BID PACKAGE 02 – ADDENDUM 01**Date:** January 10, 2020**Re:** Wilma P Mankiller Health Center Expansion**From:** James R Childers Architect, Inc.
45 South 4th Street
Fort Smith, Arkansas 72901

CHANGE NARRATIVE LETTER

TO: MATHEW THOMAS- CHILDERS ARCHITECTS
FROM: STEPHEN EDMONDSON, TREY SMITH, BETSY WELLS– HP ENGINEERING, INC.
DATE: 1/10/2020
PROJECT: WPMHC EXPANSION BID PACKAGE 02 ADDENDUM 01

SHEET NUMBER:
A1.21

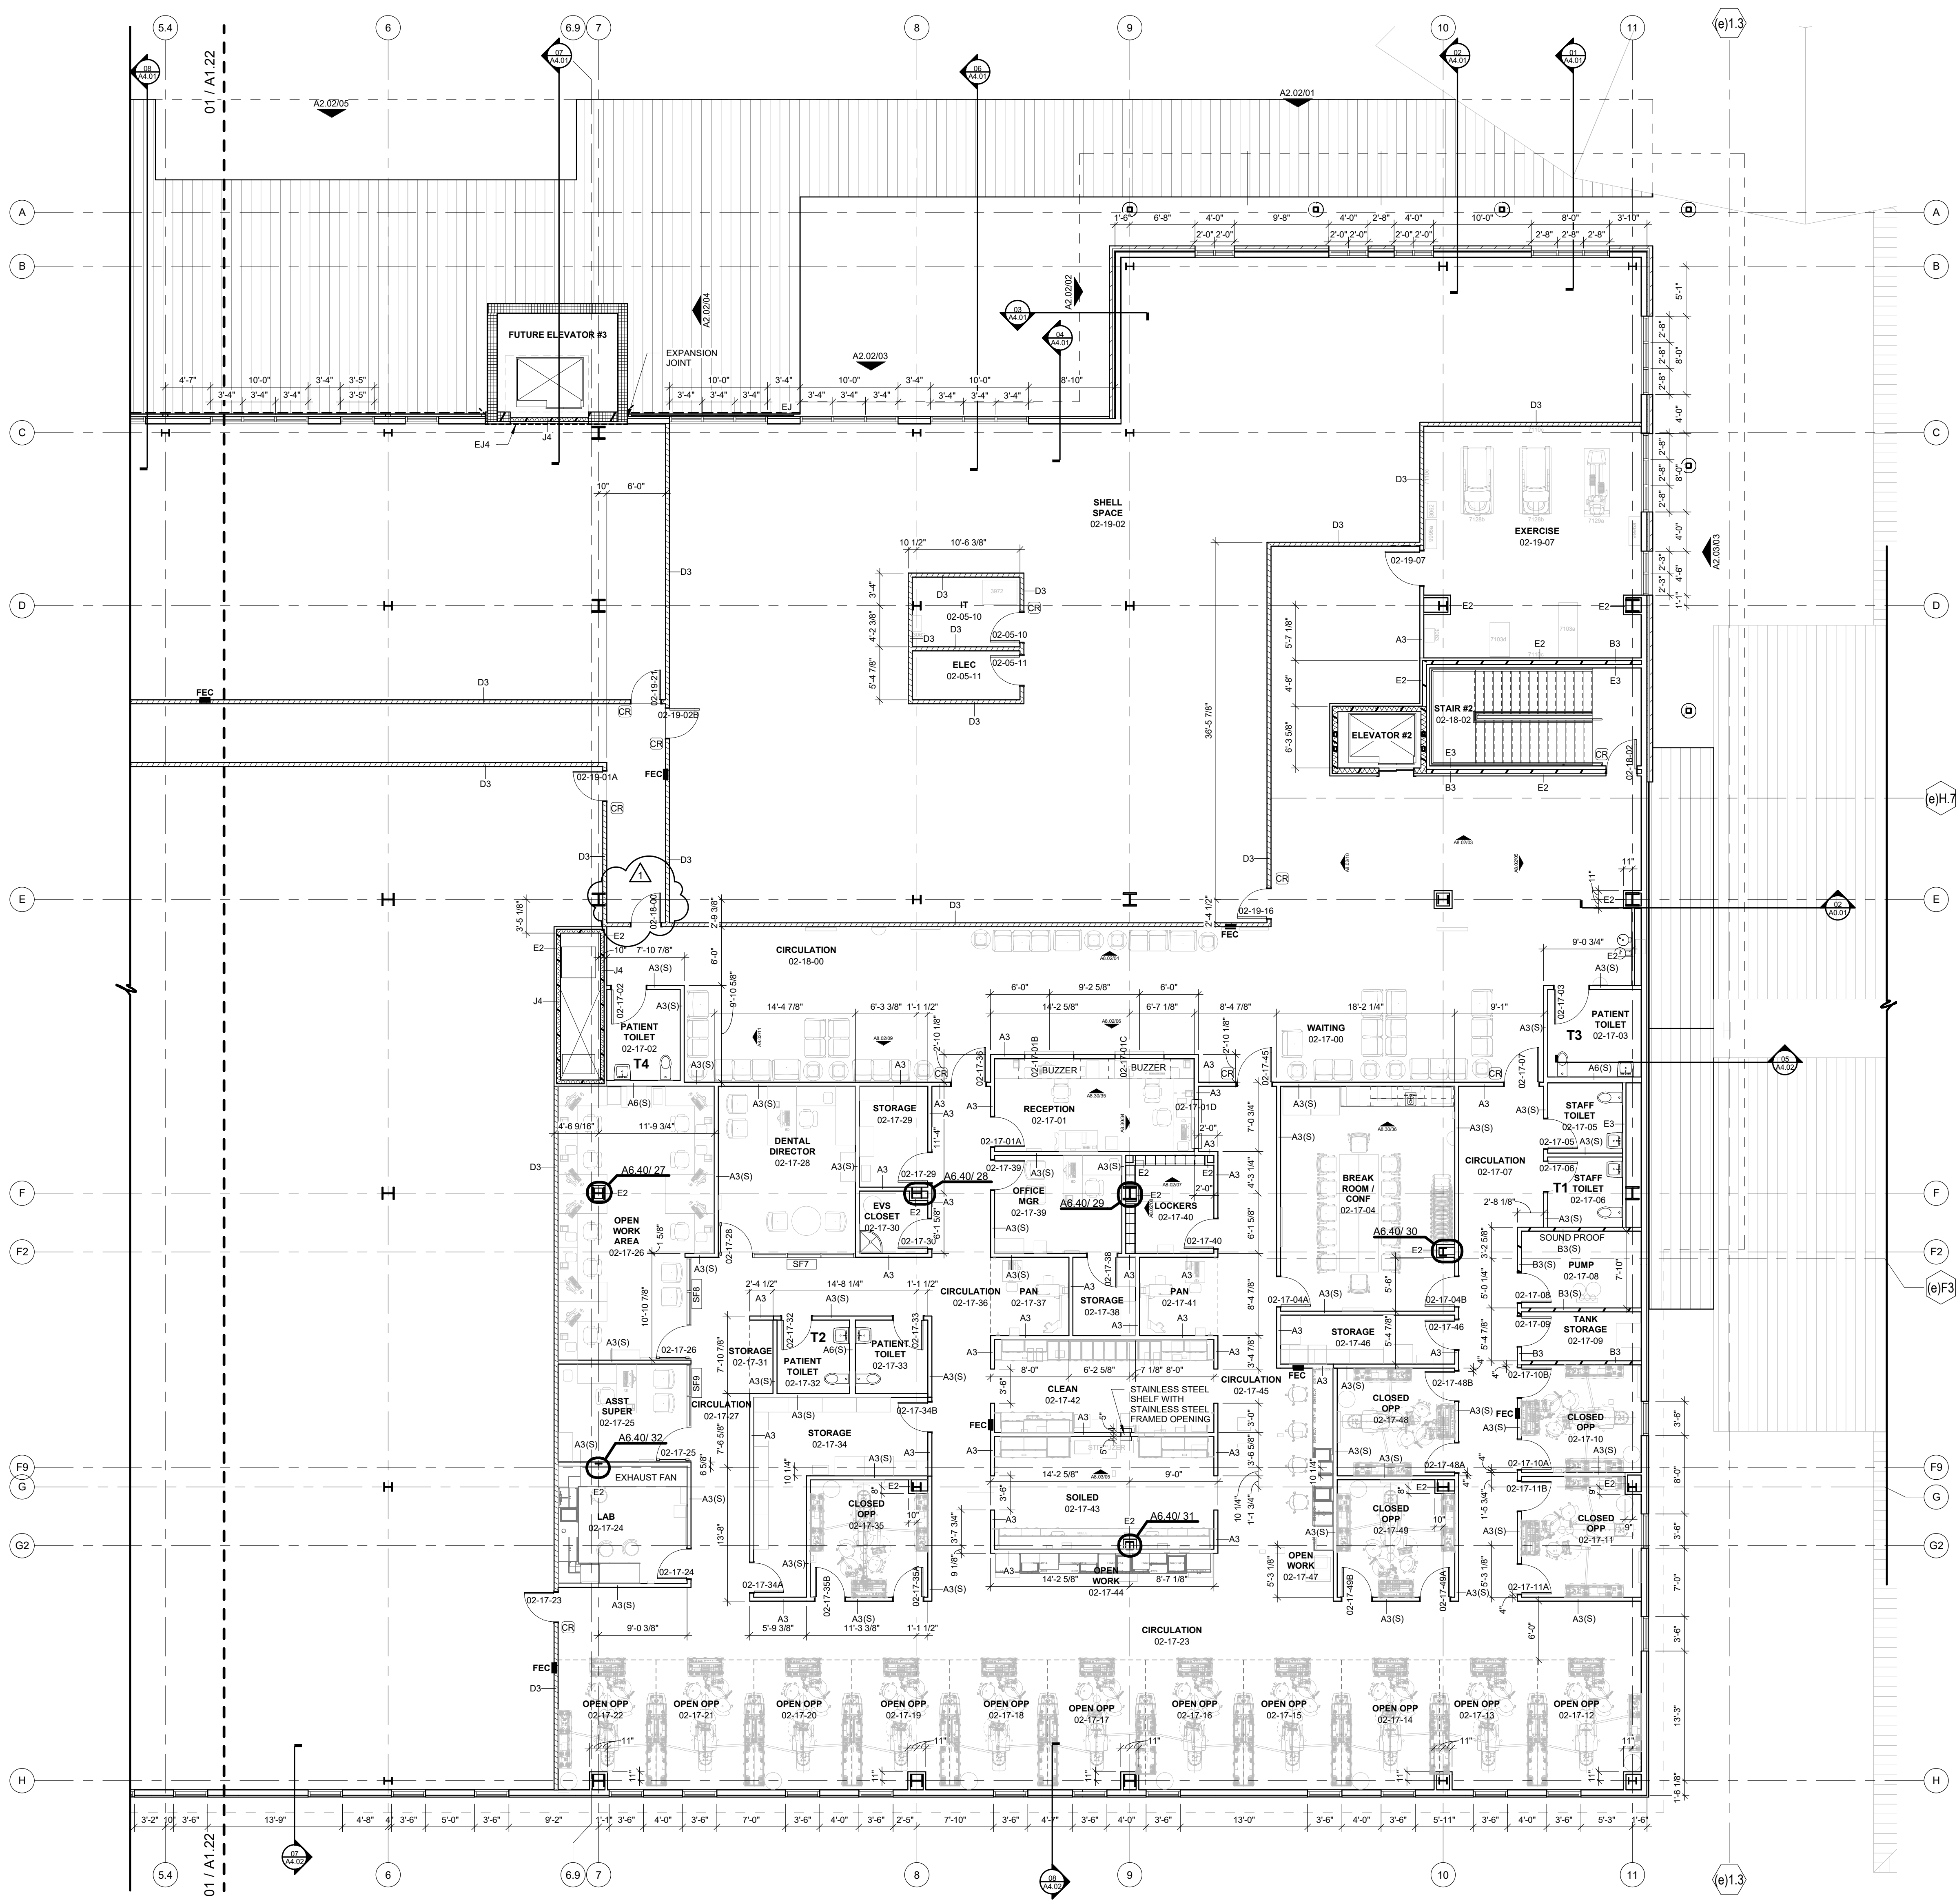
- Item 01**
- A1.21 – Added door 02-18-00
 - A1.30 – Door 03-19-01 Revised door swing.
 - A2.02 – Project phase and date revised.
 - A2.03 – Project phase and date revised.

SHEET NUMBER: A7.13

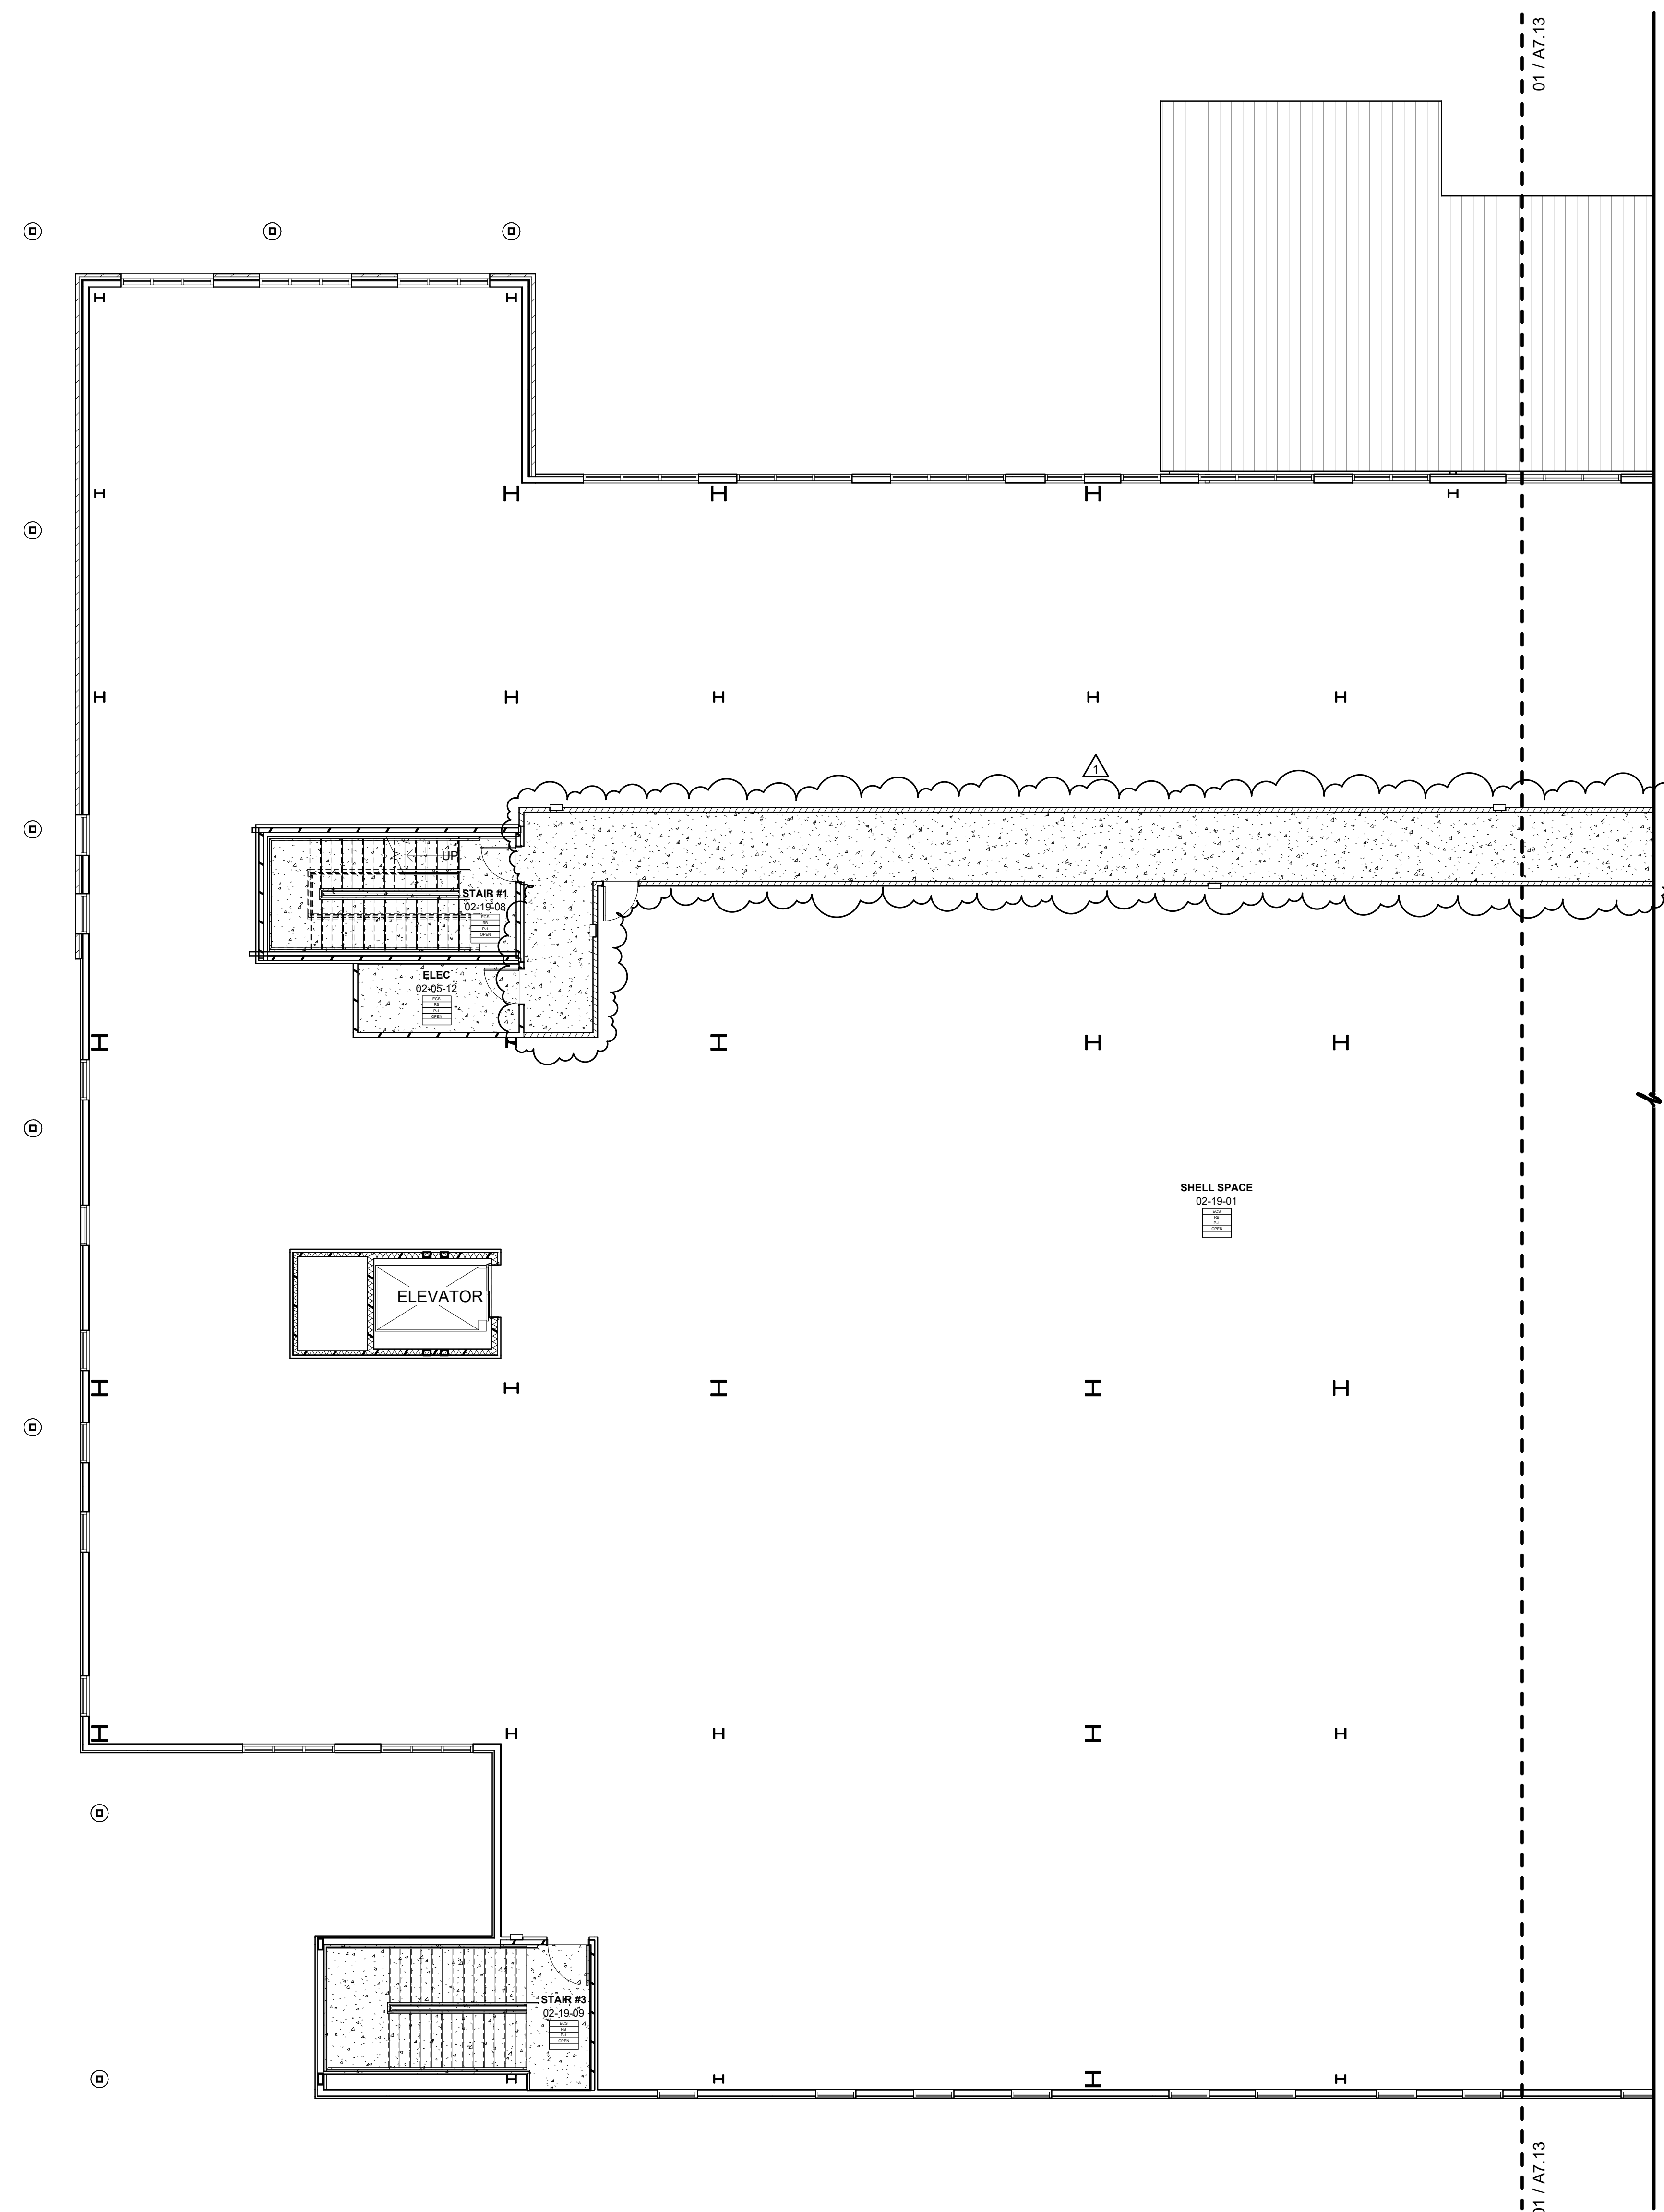
- A7.13 – Flooring changed to exposed sealed concrete in corridor.
 - A7.14 – Flooring changed to exposed sealed concrete in corridor.
 - A8.31 – Project phase and date revised.

SHEET NUMBER: A9.21

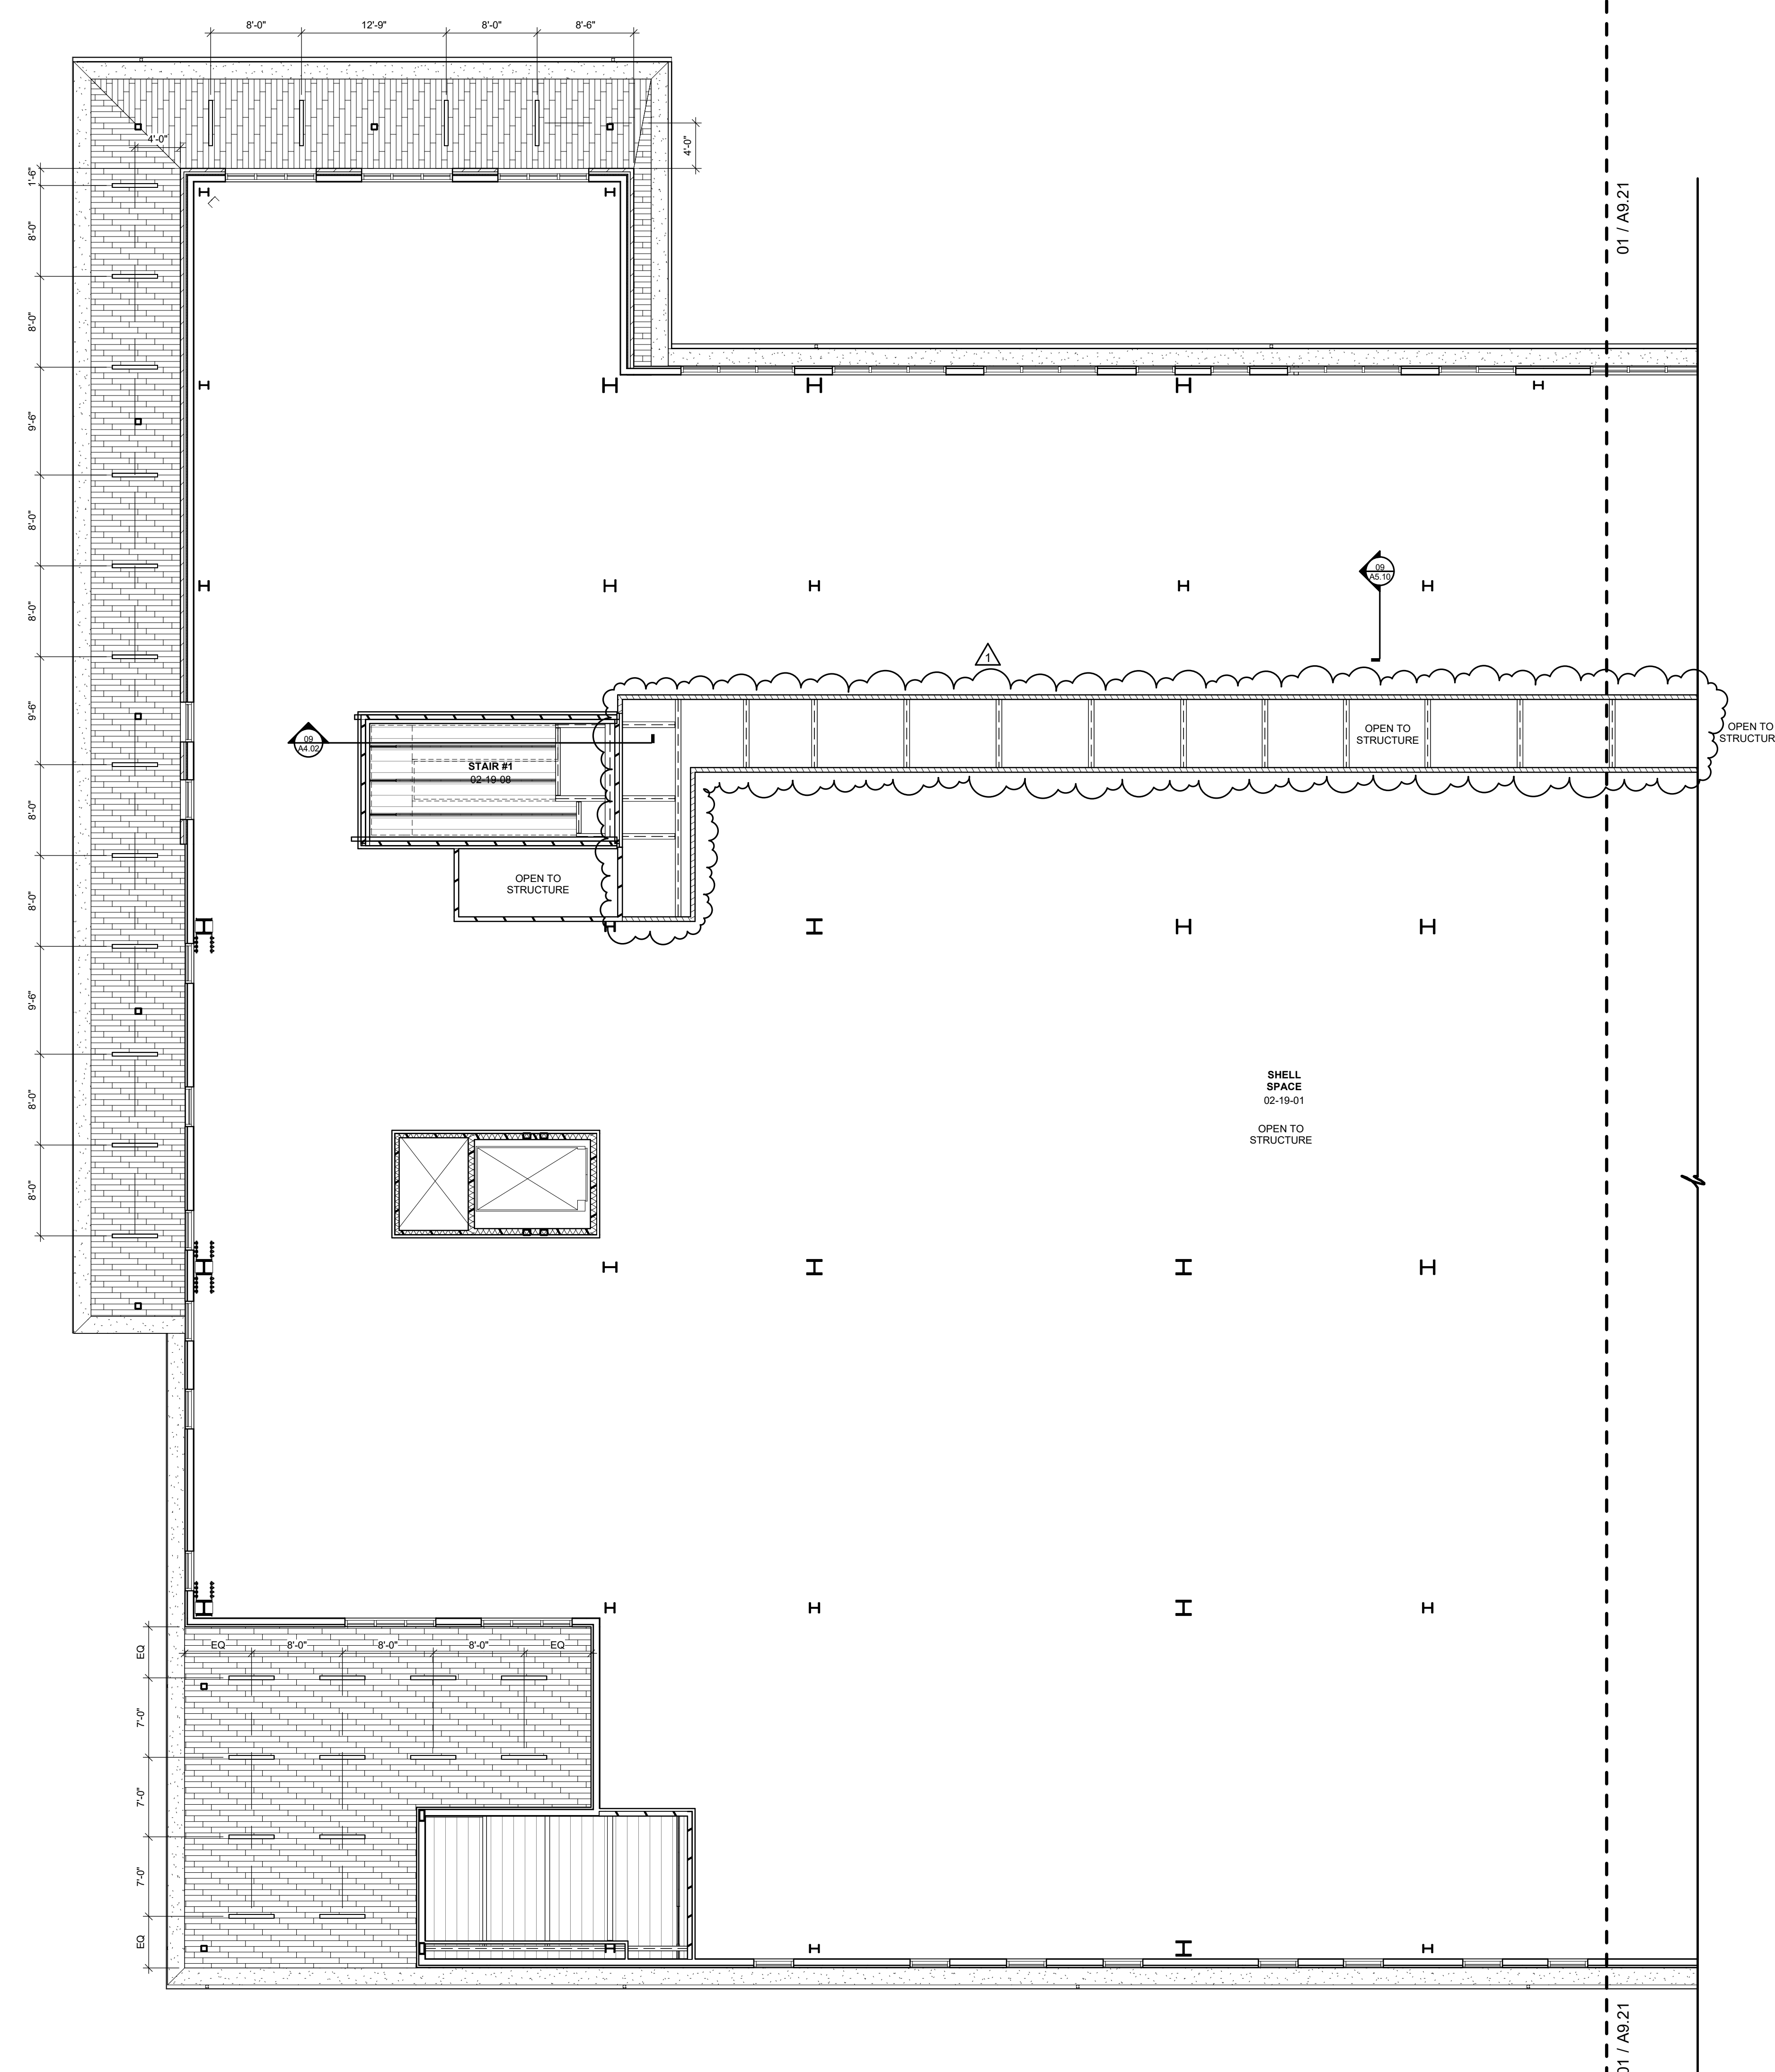
- A9.21 – Lighting fixtures taken out / Ceiling changed to open to structure.
 - A9.22 – Lighting fixtures taken out / Ceiling changed to open to structure.
